Proposed Revisions to a Standard Plans Index

Index Number: 649-010

Index Title: STEEL STRAIN POLE

Summary of the changes:

STRAIN POLE ASSEMBLY

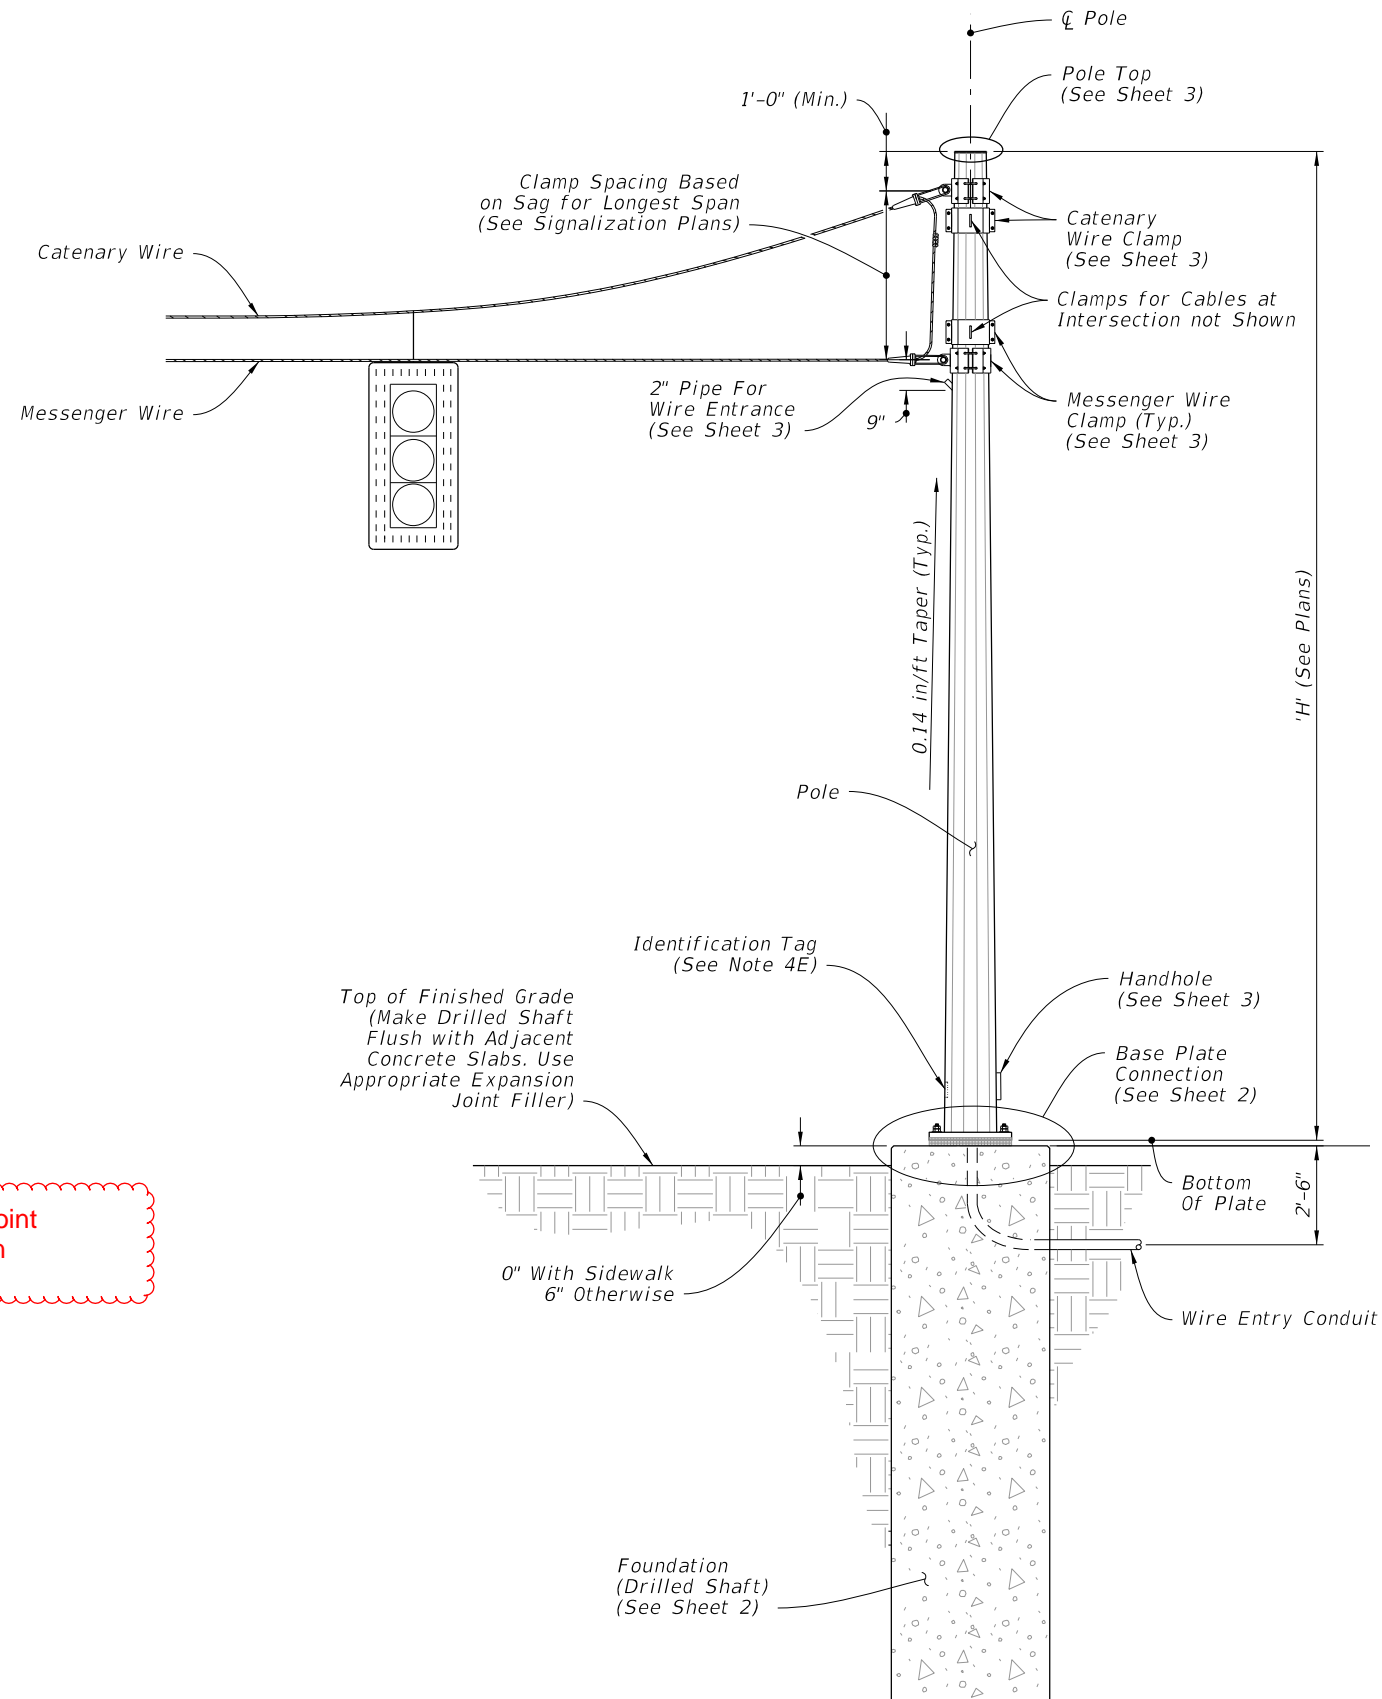
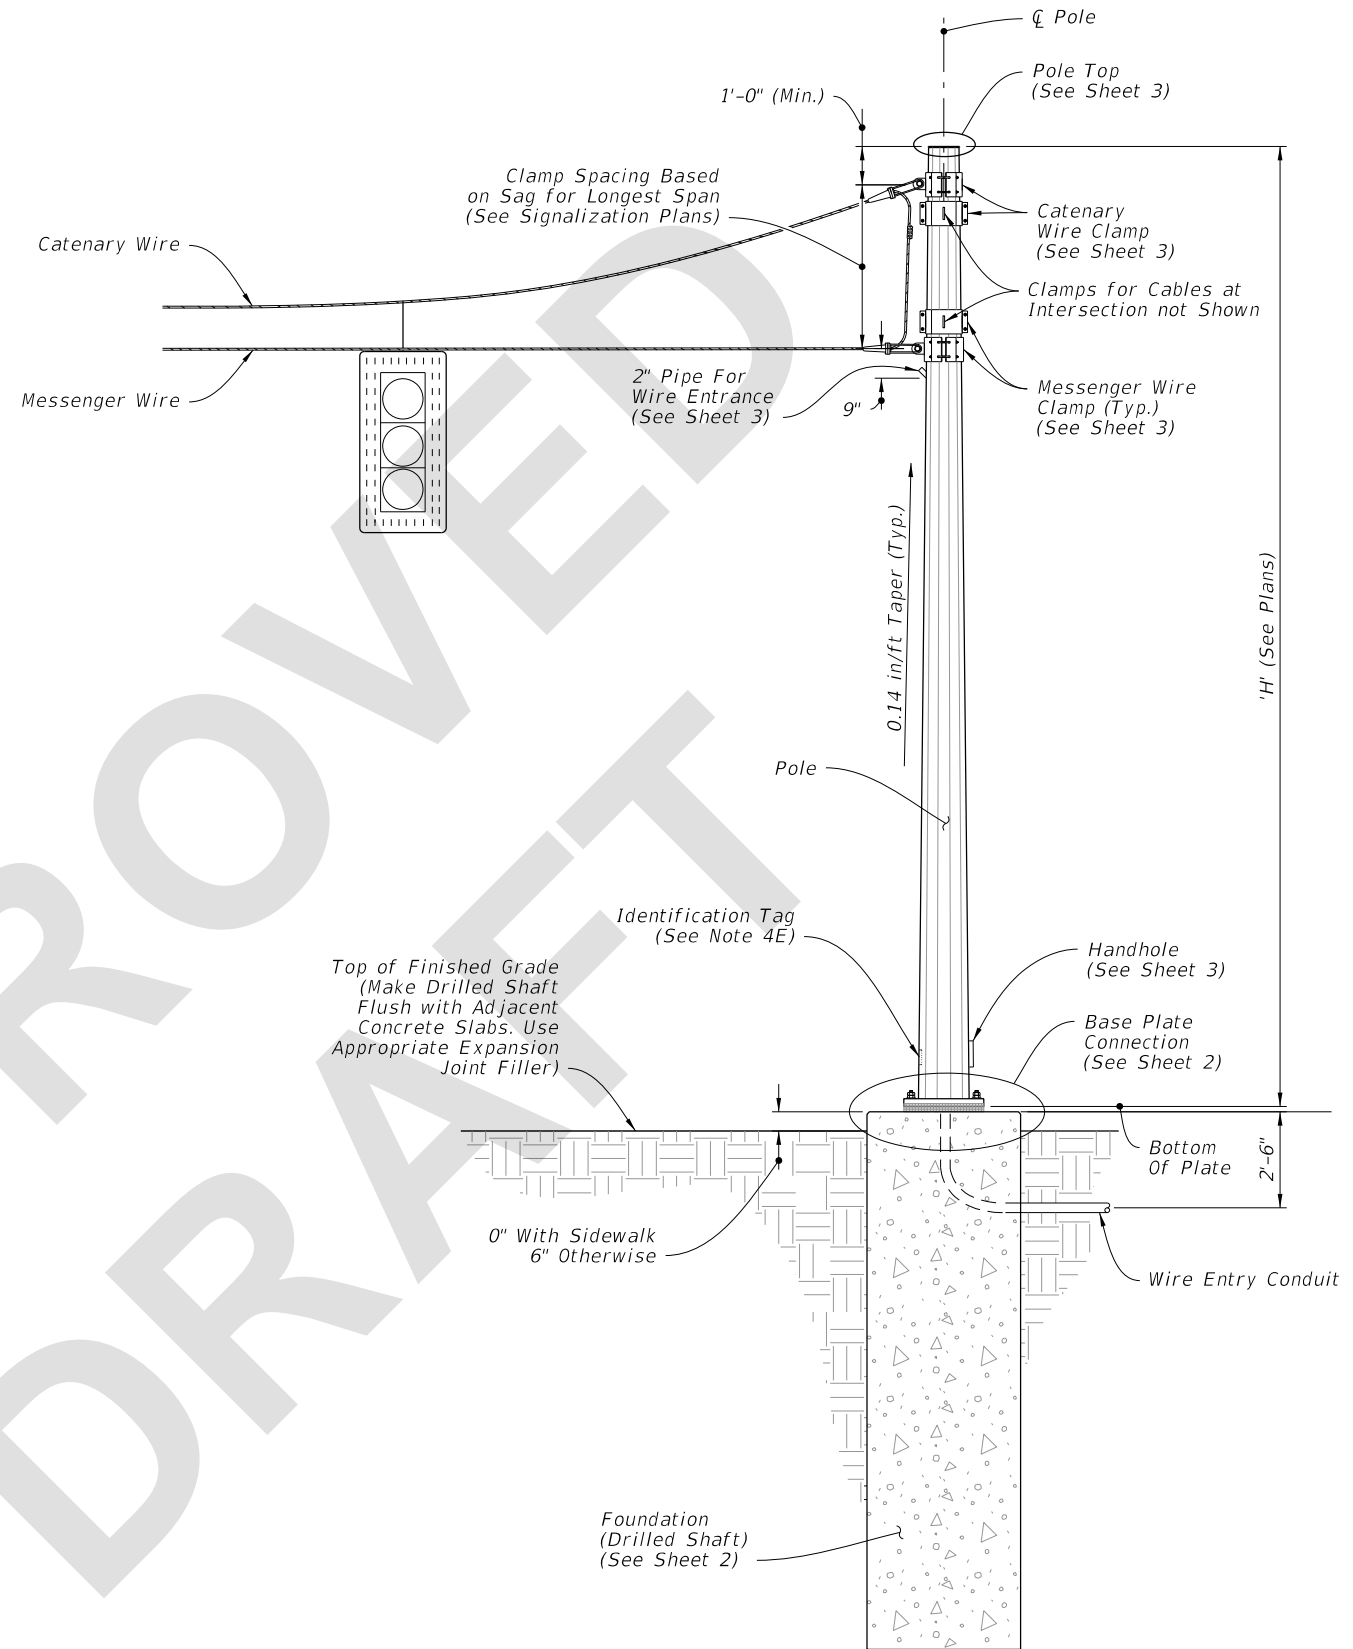
Sheet 1: Changed phrase from "full-penetration groove" to "complete joint penetration".

Sheet 1: Changing non-standard language to standard language consistent with AWS.

complete joint penetration

- G. Perform all welding in accordance with Specification 460-6.4.
- H. Fabricate longitudinal seam welds in pole with 60 percent minimum penetration or fusion welds except, within 6" of the base plate connection use complete joint penetration welds.

POLE ASSEMBLY

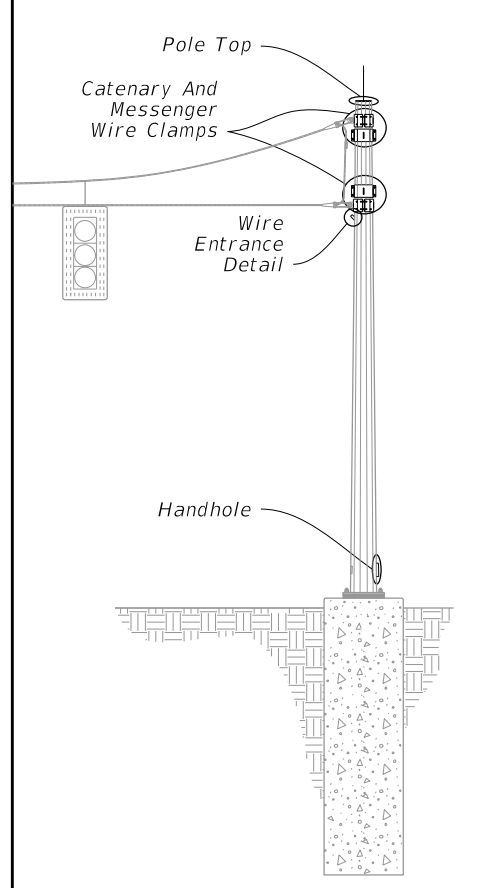
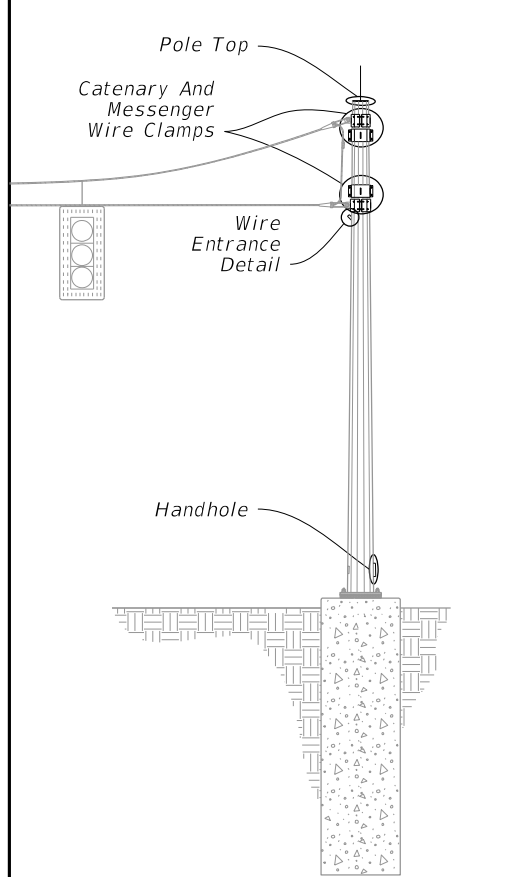
Sheet 3: Changed weld detail to say "CJP."

Sheet 3: Changing non-standard language to standard language consistent with AWS.
